**RESPONSE TO PUBLIC COMMENTS ON
DRAFT PERMIT NO. MA0003891 FOR
GENERAL ELECTRIC COMPANY
PITTSFIELD, MASSACHUSETTS**

On December 22, 2004, the U.S. Environmental Protection Agency (“EPA”) and the Massachusetts Department of Environmental Protection (“MassDEP”) released for public notice and comment draft National Pollutant Discharge Elimination System (“NPDES”) permit number MA0003891 (“Draft Permit”), which authorized discharges from a facility owned and operated by the General Electric Company (“GE” or “permittee”) to Silver Lake, Unkamet Brook, and the East Branch of the Housatonic River. These waters have been classified as Class B warm water fisheries under the Massachusetts Surface Water Quality Standards. EPA and MassDEP held a joint public hearing on the Draft Permit in Pittsfield, Massachusetts, on February 10, 2005. The public comment period for this Draft Permit ended on March 25, 2005.

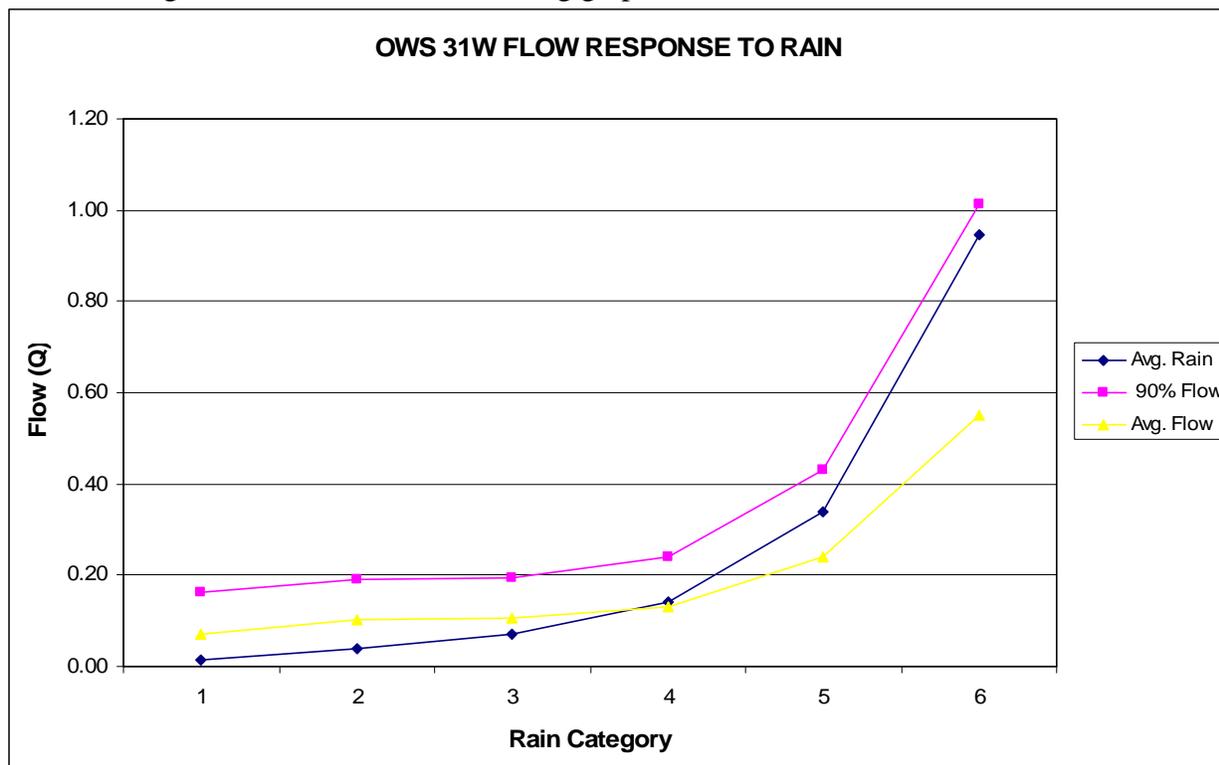
OWS 31W, which treats waters going to Outfall 001, poses unique challenges with regard to reduction of TSS. Unlike the other OWSs at the site, 31W receives municipal runoff from a large off-site drainage area (about 90 acres). The runoff from that area will contain a variety of solid materials that are not present on-site and which pose treatment difficulties for OWS 31W that are not presented for other site discharges.

Flow can be used as an indication of the potential ability for the 31W OWS to reduce influent TSS. Using Outfall 001 flow generated from 2002 to current, it is apparent that the OWS conditions during certain rain events are distinctly different from the representative OWS conditions assumed to have been the basis of the technology-based 138 lb/d. For instance, in response to rain events, there where will be a time period¹⁸ when flow through the system surges (increases), thereby reducing residence time for particle settling and causing turbulent flow through the OWS. One method to determine the average 24-hour flow that is representative of the conditions applicable to the 138 lb/d, is to evaluate the relationship between flow and rain events. The focus of this evaluation is to determine when there is a statistically noticeable flow response of the OWS (over a 24-hour period) to rain events. To have a rugged database, a rain event is defined as the sum of all rain or snow melt for the 72 hours prior. As there is a difference between flow during periods of rain (average = 0.17 mgd) and no rain (0.089 mgd), the relationship between increments of rain and the flow corresponding to those increments was used to evaluate the response of the OWS to rain-influenced flow. The increments of rain summarized into rain categories are:

This comment entirely pertains to effluent limitations for Outfall 001, which is no longer included in the permit, so there is no need to respond to the specific issues raised in the comment. However, the general theme of this comment is that the BPJ effluent limitations included in the 1992 permit should be made less stringent based on concerns that storm water flows greater than approximately 0.4 MGD may cause violation of the limits. It is unclear what relevance GE's record of compliance with the permit limit has to the validity of the permit limit itself. This comment seems to contend that BPJ limits established in the prior permit should be made less stringent if operational data shows that the limits are not being achieved, and that a new limit should be established to reflect actual performance of the existing treatment facilities. This conclusion is incorrect. Exceedances of BPJ limitations are enforceable conditions of NPDES permits. If the BPJ limitations are not being attained by the existing facility, the permittee should provide additional treatment in order to achieve the limits.
